FINAL DRAINAGE REPORT
for
THE COMMONS AT FALCON FIELD FILING NO. 2

April 2026

PCD FILE NO. SF255

DR1

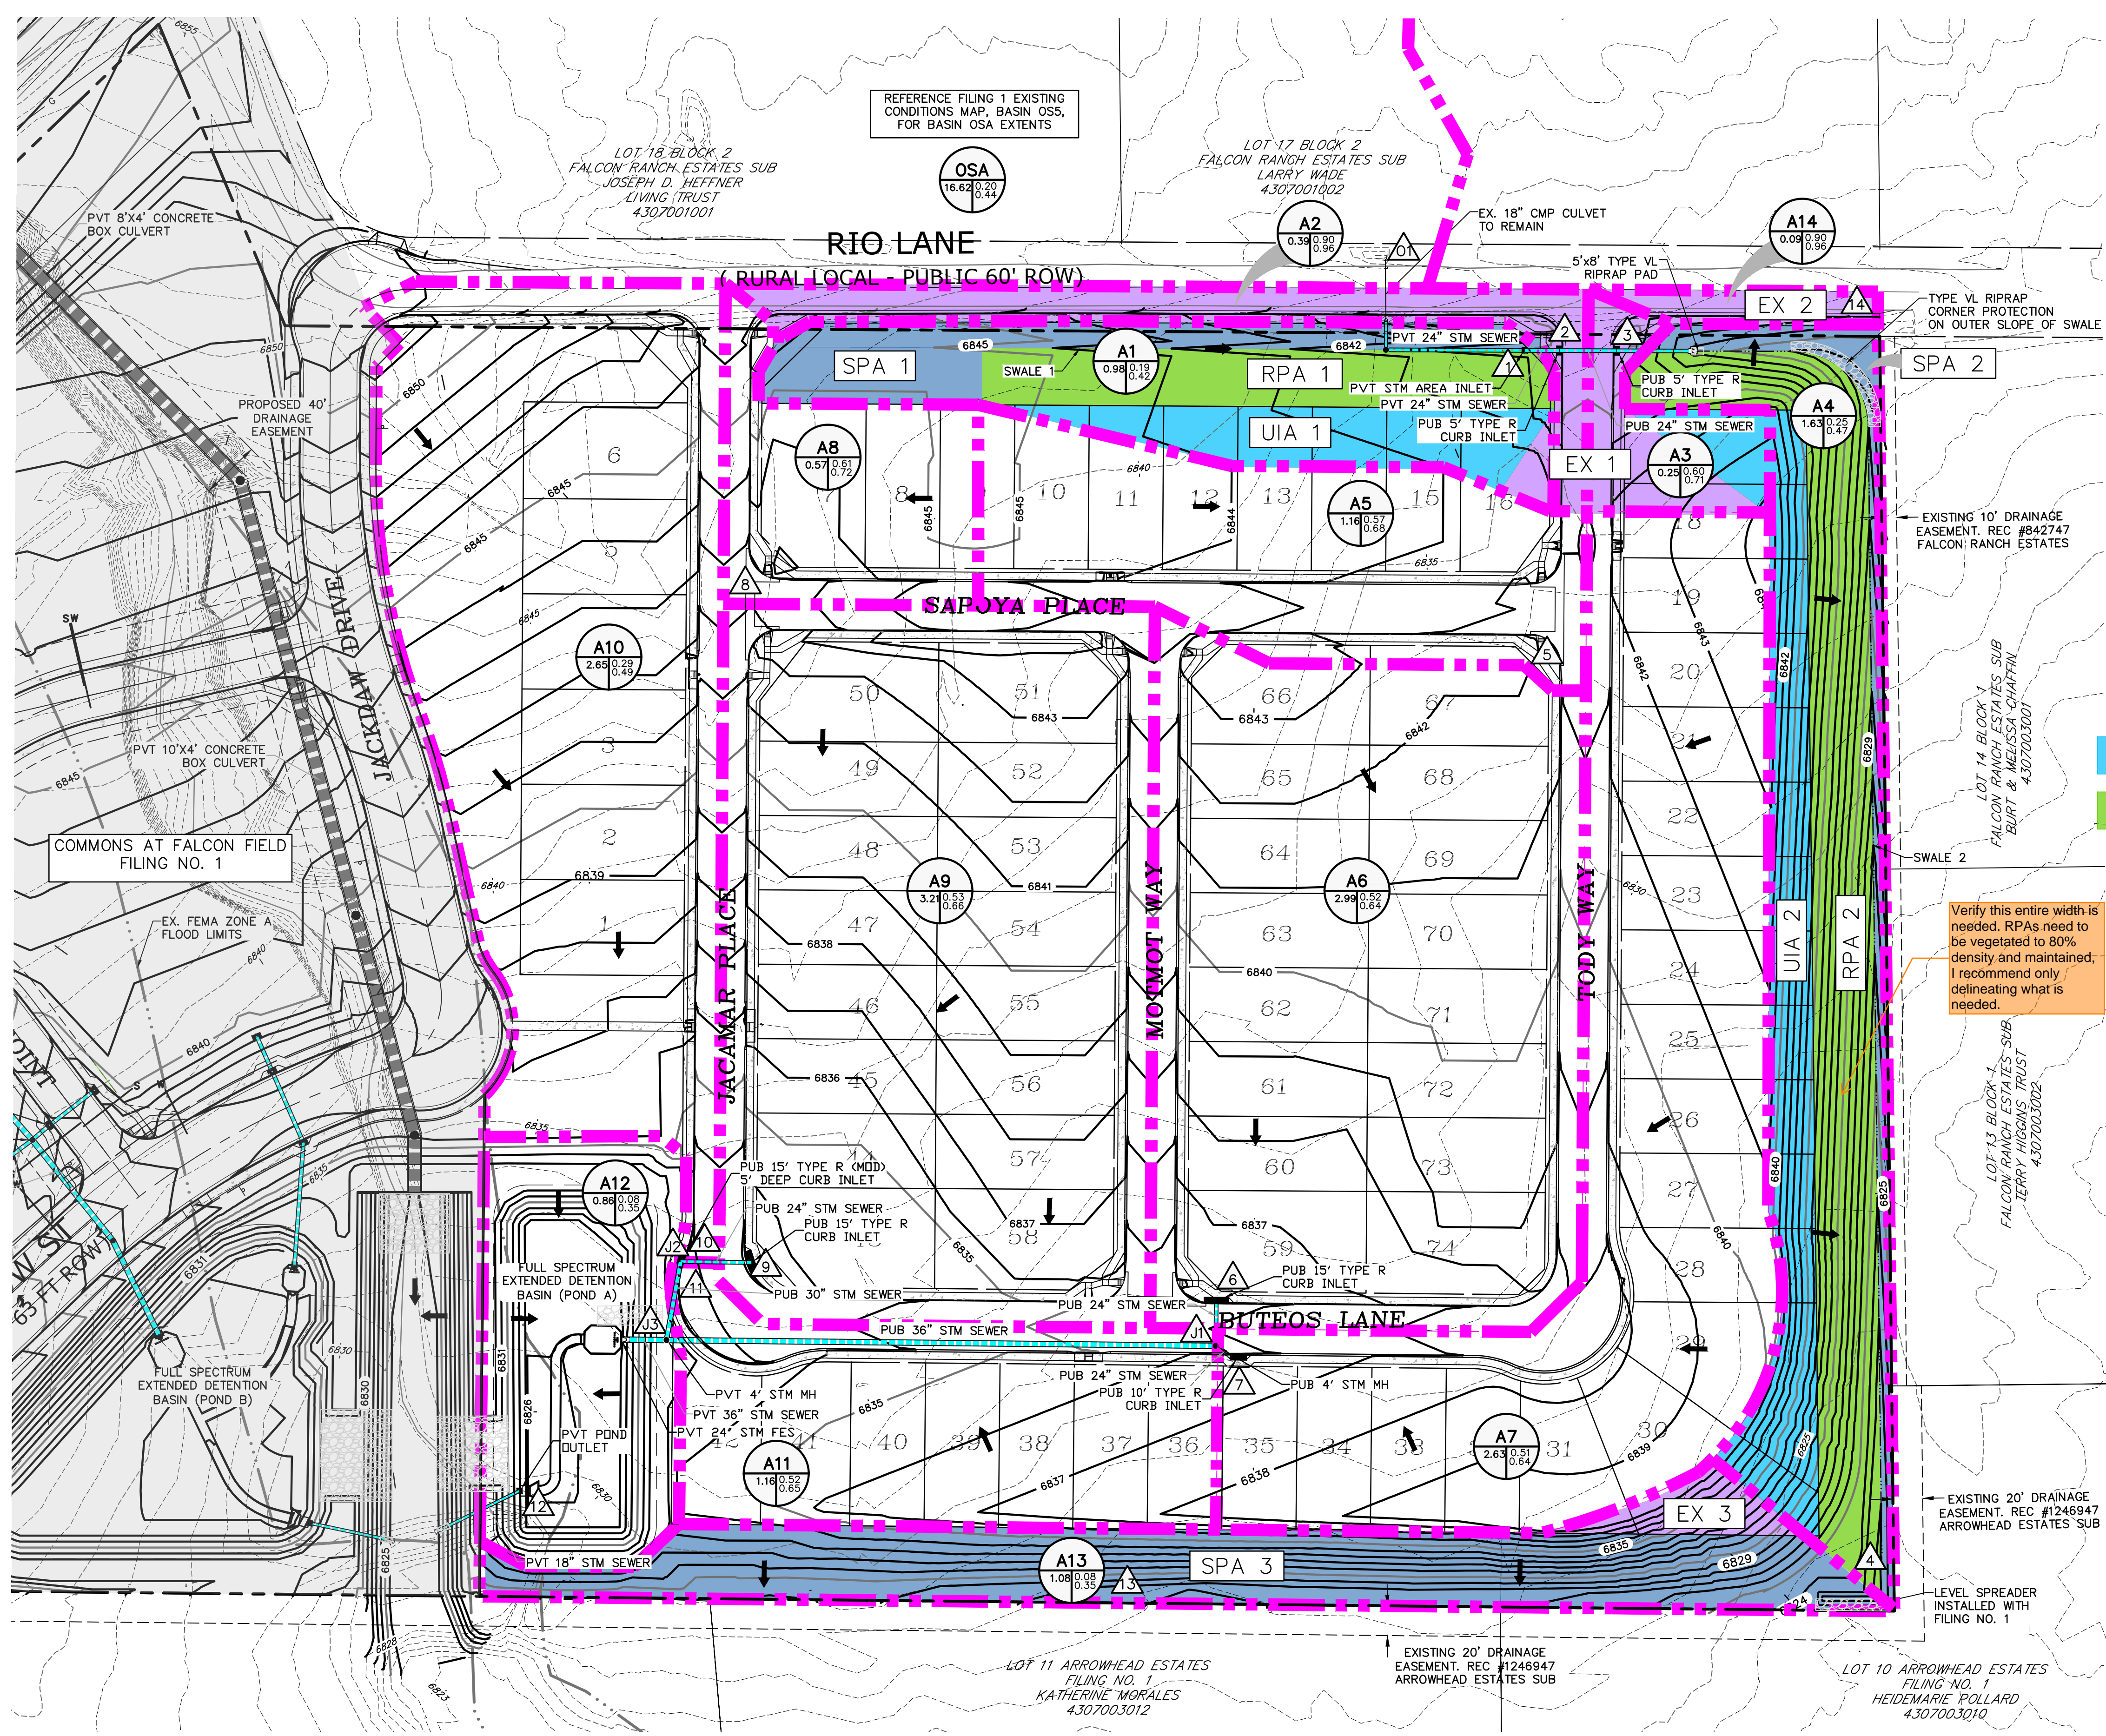
Verify this entire width is needed. RPAs need to be vegetated to 80% density and maintained. I recommend only delineating what is needed.
